SUBJECT: ISSUANCE OF AMENDMENT NO. 30 TO FACILITY OPERATING LICENSE
NPF-63 REGARDING CHANGE IN REFUELING WATER STORAGE TANK AND SAFETY
INJECTION ACCUMULATOR BORON CONCENTRATION - SHEARON HARRIS NUCLEAR
POWER PLANT, UNIT 1 (TAC NO. M82941)

AMENDMENT NO. 30 TO FACILITY OPERATING LICENSE NO. NPF-63 - HARRIS, UNIT 1

SAFETY EVALUATION BY THE OFFICE OF NUCLEAR REACTOR REGULATION
RELATED TO AMENDMENT NO. 30 TO FACILITY OPERATING LICENSE NO. NPF-63

SHEARON HARRIS NUCLEAR POWER PLANT, UNIT 1

FIGURE 3.1-1
 SHUTDOWN MARGIN VERSUS RCS BORON CONCENTRATION
 MODES 3, 4 AND 5/DRAINED

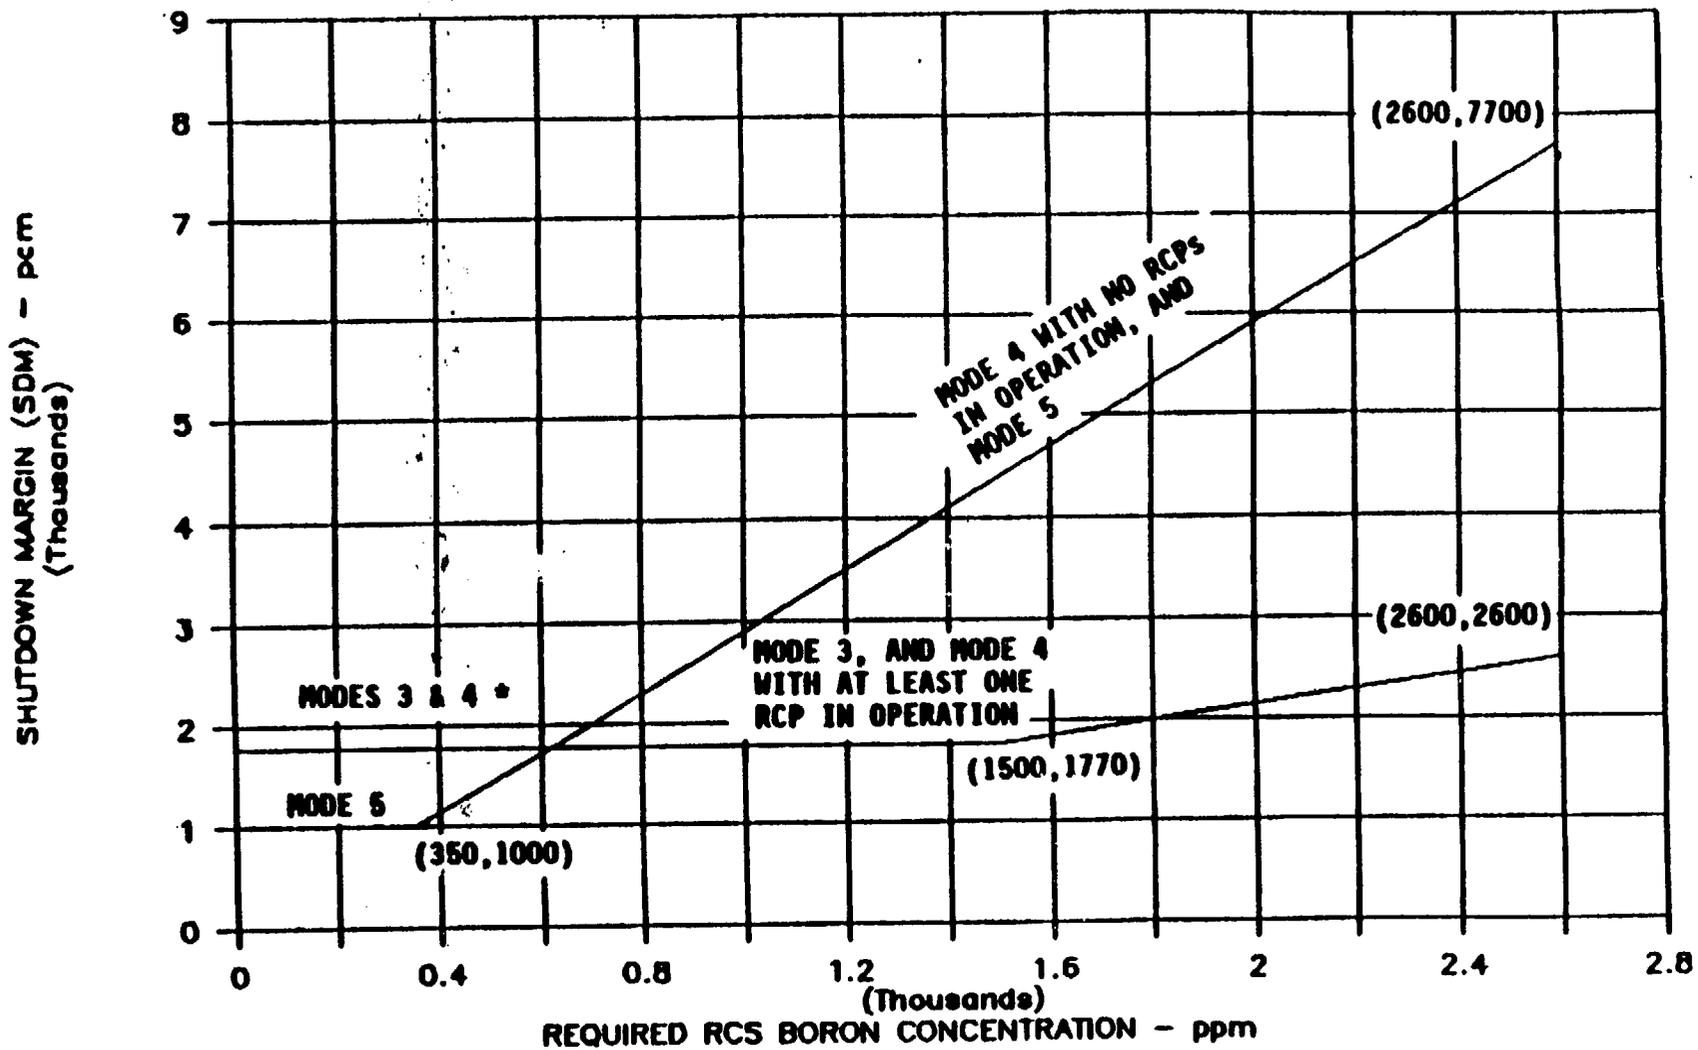
Reanalysis of the boron dilution accident for Modes 3, 4, and 5 resulted in a slightly revised TS Figure 3.1-1 to ensure a minimum of 15 minutes for operator action prior to a loss of shutdown margin in a dilution accident and to ensure that all shutdown margin criteria satisfy all TS Bases. CP&L has found that the current analysis result for the inadvertent boron dilution event in Modes 1, 2, and 6 remains valid. Also, an inadvertent boron dilution event in Mode 6 is precluded by administrative procedures. The boron dilution event is sensitive to core design and is evaluated by CP&L in the reload safety evaluation (RSE) for each cycle.
